# Access Compliance Report

## Public Rights-of-Way

### (Curb Ramps)

Intersection ID: 48642	Main Street: BROCK_RN	Cross Street: EASTFIELD_VILLAGE_LN	Location: E
ADA ID: F74DA6D235CD	Ramp Type: Perp	Initial Pass/Fail: Fail	Overall Compliance: No
Severity Score: 13.75			
Codes/Mitigation Info/Possible Solution		Field Measurements/Component Compliance

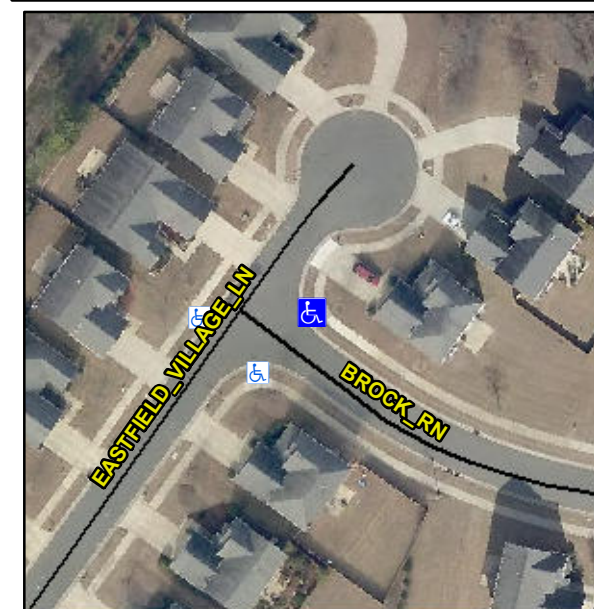
**Not Found, R304.2.2, R304.5.3**

Compliance	Description	Data	Compliance	Description	Data
N/A	Ramp Length (in)	71.0	No	Ramp Slope (%)	8.6
Yes	Ramp Width (in)	48.0	No	Ramp XSlope (%)	2.8
N/A	Flare Type LT	N/A	N/A	Flare Type RT	N/A
N/A	Flare Slope LT (%)	N/A	N/A	Flare Slope RT (%)	N/A
N/A	Flare Traversable LT?	N/A	N/A	Flare Traversable RT?	N/A
N/A	Landing Length (in)	N/A	N/A	DWS Provided?	N/A
N/A	Landing Width (in)	N/A	N/A	DWS Contrast?	N/A
N/A	Landing Slope (%)	N/A	N/A	DWS Length (in)	N/A
N/A	Landing X Slope (%)	N/A	N/A	DWS Full Width?	N/A
N/A	Landing Curb? (Y/N)	N/A	N/A	DWS Offset (in)	N/A
N/A	Shared Landing?	N/A			
N/A	Gutter Ponding?	N/A	N/A	Gutter Slope (%)	N/A
N/A	Gutter Lip Ht (in)	N/A	N/A	Gutter X Slope (%)	N/A
N/A	Painted X Walk1?	No	N/A	Painted X Walk2?	N/A
	X Walk 1 Direction	To SW		X Walk 2 Direction	N/A
N/A	X Walk 1 Width (in)	N/A	N/A	X Walk 2 Width (in)	N/A
	X Walk 1 Slope (%)	2.3		X Walk 2 Slope (%)	N/A
	X Walk 1 X Slope (%)	2.1		X Walk 2 X Slope (%)	N/A

**Remove & Replace Entire Ramp.**
